Exhibit A1
Staff Report
Wilsonville Planning Division
Primary School in Frog Pond
Development Review Board Panel 'A'
Quasi-Judicial Public Hearing
Amended and Adopted April 10, 2023
Added language ***bold italics underline***
Removed language ~~struck through~~

Hearing Date:	April 10, 2023
Date of Report:	April 3, 2023
Application No.:	DB22-0012 Primary School in Frog Pond
Request/Summary:	The requests before the Development Review Board include Stage 1 Preliminary Plan, Stage 2 Final Plan, Site Design Review, Class 3 Sign Permit and Waivers, and Type C Tree Removal Plan
Location:	7151 SW Boeckman Road. The property is specifically known as Tax Lot 4500, Section 12DC, and Tax Lot 400, Section 12DD, Township 3 South, Range 1 West, Willamette Meridian, City of Wilsonville, Clackamas County, Oregon.
Owner/Applicant:	West Linn-Wilsonville School District (Contact: Remo Douglas)
Authorized Representative:	Keith Liden, AICP
Comprehensive Plan Designation:	Public
Zone Map Classification:	Public Facility
Staff Reviewers:	Cindy Luxhoj AICP, Associate Planner Amy Pepper, PE, Development Engineering Manager Kerry Rappold, Natural Resources Manager
Staff Recommendation:	<u>Approve with condit

Block, Access, and Connectivity Consistent with Frog Pond West Neighborhood Plan
Subsection 4.127 (.10) and Figure 18. Frog Pond West Master Plan

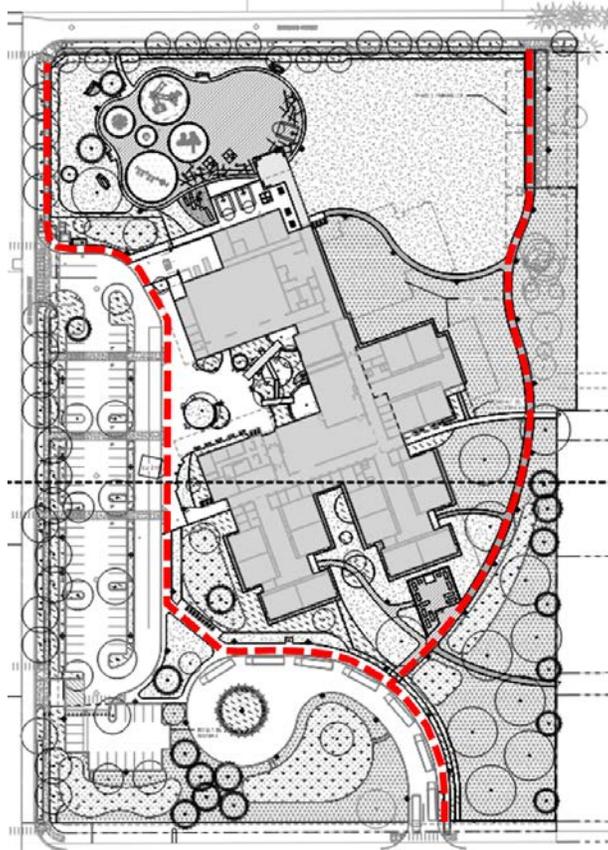
B21. The Street Demonstration Plan is an illustrative layout of the desired level of connectivity in the Frog Pond West neighborhood and is intended to be guiding, not binding, allowing for flexibility provided that overall connectivity goals are met. As shown in the portion of Figure 18 below, SW Sherman Drive borders the subject property on the west, SW Brisband on the north, and SW Boeckman Road on the south, with a Pedestrian Connection connecting SW Brisband Street to SW Boeckman Road on the east side of the school site and west side of the future park site (land banked).

The block size and shape, access, and connectivity of the proposed school site complies with Figure 18 of the Frog Pond West Master Plan or is an allowed variation as shown in the table below.

The applicant has proposed an alternative to the Pedestrian Connection shown in Figure 18 along the property's east boundary. As described in their Code response and shown in the illustration below, a pathway from the SW Boeckman Road sidewalk travels north along the bus lane to a path that meanders north along the eastern side of the school building to SW Brisband Street. For security purposes, this path will be gated during school hours but opened to the public at other times to facilitate access. During school hours the pedestrian route would continue along the bus lane to the front of the building and then onto the northwest corner of the site along SW Sherman Drive, which then connects to SW Brisband Street, thus completing the intent of the Master Plan while addressing school security.

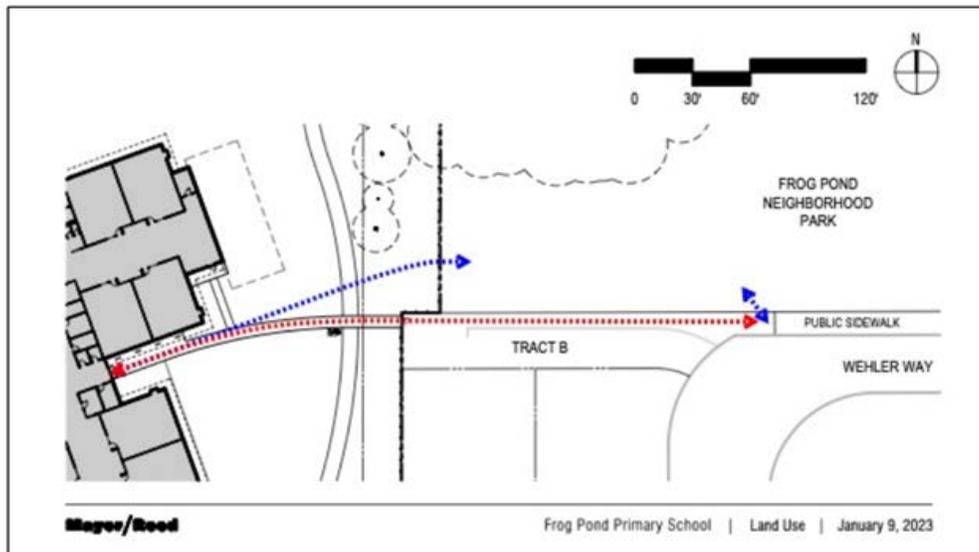
The pathway on the east side of the site that connects the sidewalk along the bus aisle with the sidewalk in SW Brisband Street at the north end of the site is proposed to be a combination of pedestrian asphalt paving, concrete, and/or compacted aggregate paving surface to provide ADA accessibility (see Sheets LU 202 and LU 203 in Exhibit B2). Two (2) pathways connecting the school property to SW Wehler Way also are proposed to be this combination of materials depending on location within the site. As illustrated below, there are two (2) options for the northern connection to SW Wehler Way: through the future City park property (the applicant's preferred option); or on the north side of private Tract B in the Stafford Meadows subdivision.

Frog Pond West Specific Fence Standards
 Subsections 4.127 (.17)

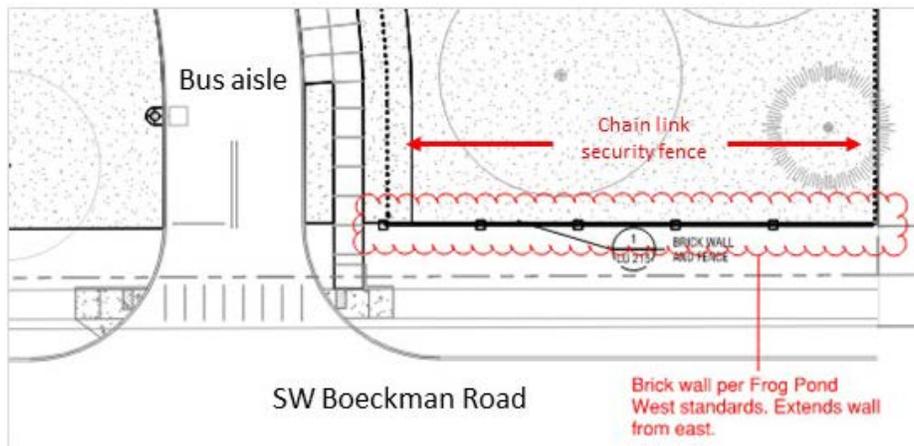
B22. Within Frog Pond West, fences must comply with standards in 4.113 (.07) except that columns for the brick wall along SW Boeckman Road are to be placed at lot corners where possible; a solid fence taller than four (4) feet in height is not permitted within eight (8) feet of the brick wall along SW Boeckman Road except for fences placed on the side lot line that are perpendicular to the brick wall and end at a column of the brick wall; and height transitions for fences must occur at fence posts. As shown in the illustration below, the applicant proposes a brick wall along the SW Boeckman Road frontage at the southwest corner of the site as an extension of the existing brick wall to the east. The wall is proposed to stop at the east edge of the bus entry driveway; no brick wall is proposed on the west side of the bus aisle to the southwest corner of the site. As described by the applicant, this proposed gap in the wall will improve visibility to and from the school site, benefiting security as well as navigation to the school. The gap will also serve to emphasize the native plantings and stormwater features at the southwest corner and along the southern edge of the property. A detail of the brick wall that is consistent with the standards of Section 4.127 (.17) and the Frog Pond West Master Plan is included in Sheet LU 215 of the applicant's materials (Exhibit B2).

A perimeter 6-foot high chain link security fence is proposed to enclose areas occupied during the school day, such as the playground, field, and classroom wings in the north and east portions of the site to protect building entries and students and staff during school time exterior activities. The parking area and main building entry on the west side of the site, and the bus drop-off/pick-up area are outside the fenced area and open to the public throughout the day. The fence gates will be locked during school hours but opened at other times to facilitate community access to interior pathways, playground, and fields. As shown in the illustration above, the security fence is perpendicular to the brick wall along SW Boeckman Road as required. The applicant’s Sheet LU 217 (Exhibit B2) provides a detail of the chain link fence design.

Mixed Solid Waste and Recycling Areas Location Standards Subsection 4.430 (.02)

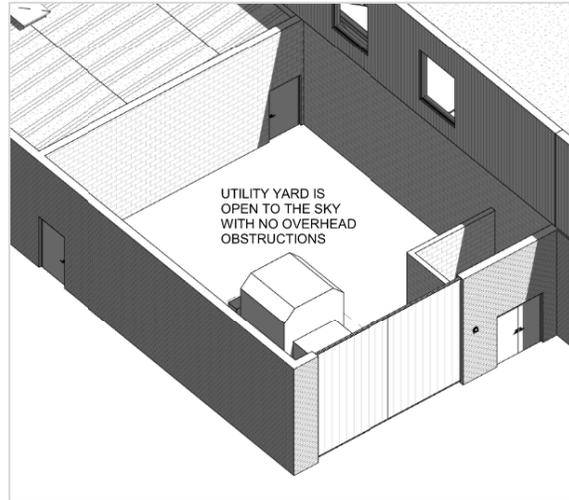
- C7.** The proposal provides a storage area for solid waste and recyclables at the northwest corner of the building. As noted in Findings B78 and B79, the proposed storage area is approximately 717 square feet in size within a 1,380-square-foot utility yard, which substantially exceeds the requirement of 289 square feet for the proposed primary school use.

Collection Vehicle Access, Not Obstruct Traffic or Pedestrians
 Subsections 4.430 (.02) G.

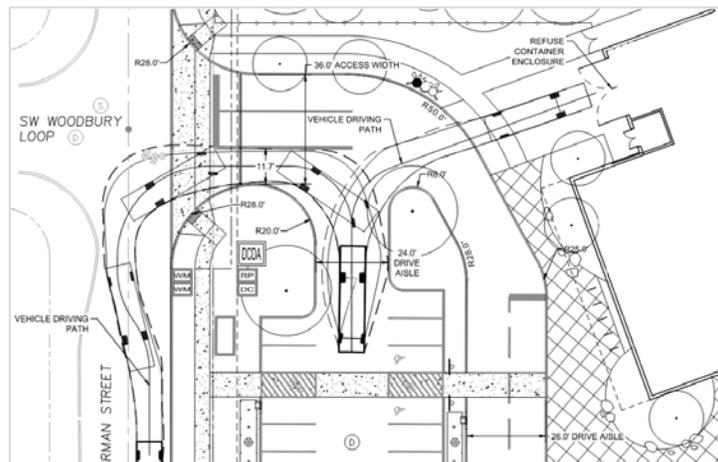
C10. The letter from Republic Services, included in the applicant’s materials in Exhibit B1, indicates the location and arrangement is accessible to collection vehicles, as shown in the illustration below. The location of the storage area does not impede sidewalks, parking area aisles, or public street right-of-way.

Prohibited Signs-Changeable Copy Signs
Subsection 4.156.06 (.01) D.

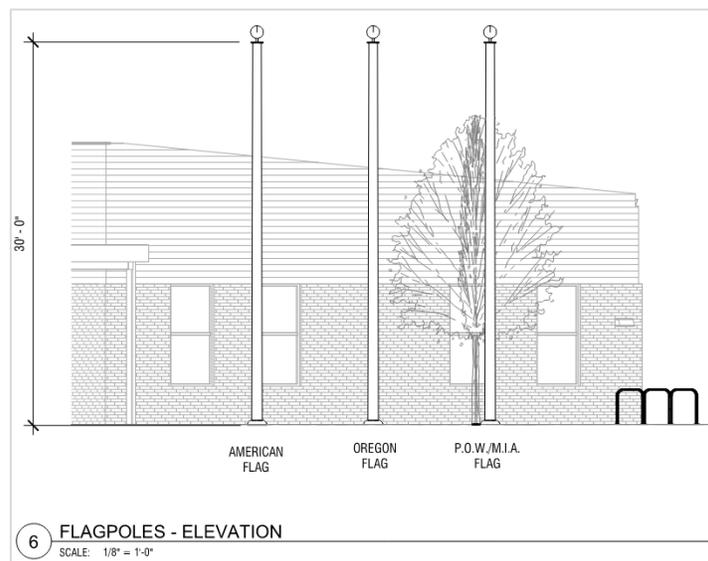
D10. Changeable copy signs that use lighting changed digitally, unless specifically approved through a waiver process connected with a Class 3 Sign Permit or Master Sign Plan, are prohibited. The applicant has applied for a waiver to allow an electronic reader board as part of the monument sign proposed on the south side of the driveway on SW Sherman Drive.

3 MONUMENT SIGN ELEVATION - FRONT & BACK
SCALE: 1" = 1'-0"

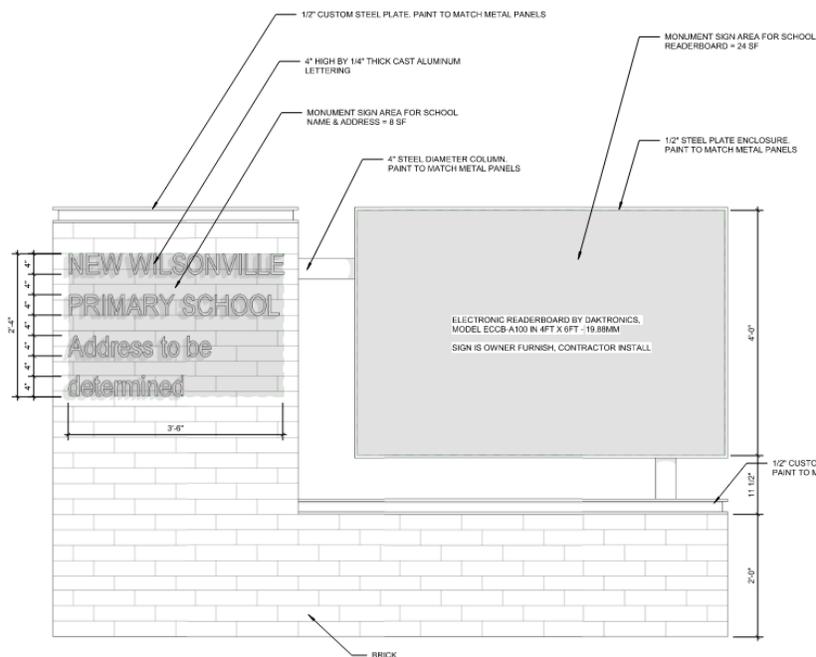
Including an electronic reader board in the proposed monument sign, as described in the applicant’s narrative, improves sign functionality by facilitation remote regulation of the sign’s operation by the school, allowing easy message changes and real-time updates to the

signage outside the school, and enabling the District to inform school visitors of upcoming events, or announce school closures or delays in the event of inclement weather. The proposed design is for text only, in one color of red, with no display of graphics or animations, oriented to be seen along SW Sherman Drive at the main entry to the school.

Subsection 4.156.08 (.02) B.5.a

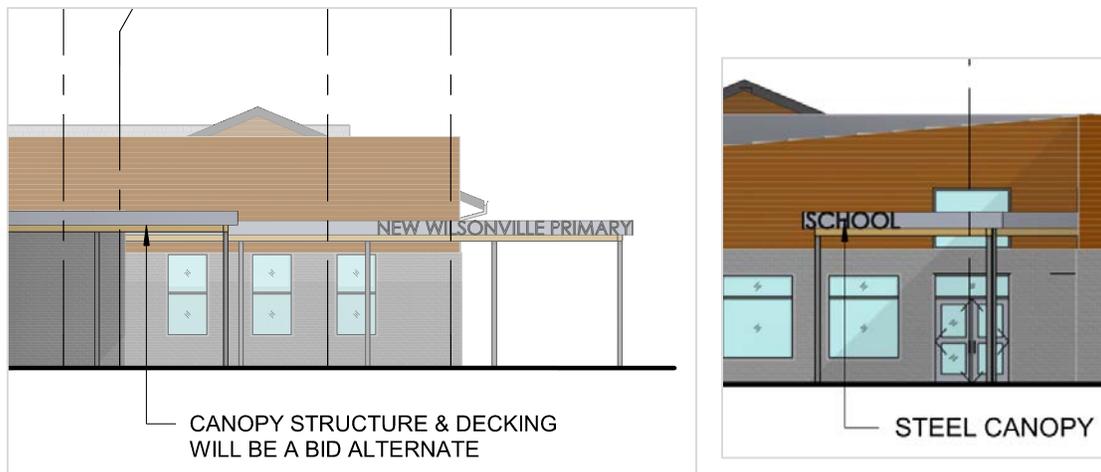
D29. As described by the applicant and shown on the plans and in the illustration below, the building-mounted sign is proposed to be located on the walkway canopy near the main front entrance, and will wrap around the west corner of the canopy. The northwest facing portion of the sign is 41 square feet (Sheet LU 350) on a building façade in excess of 140 feet, and the west facing portion of the sign is 13 square feet on a façade length over 370 feet. The code allows a sign area of 36 square feet for building facades lengths greater than 72 feet with an allowance to 12 additional square feet of sign area for every additional 24 feet of façade length. Each portion of the sign easily satisfies this standard. No signs are proposed on the north or south façades.
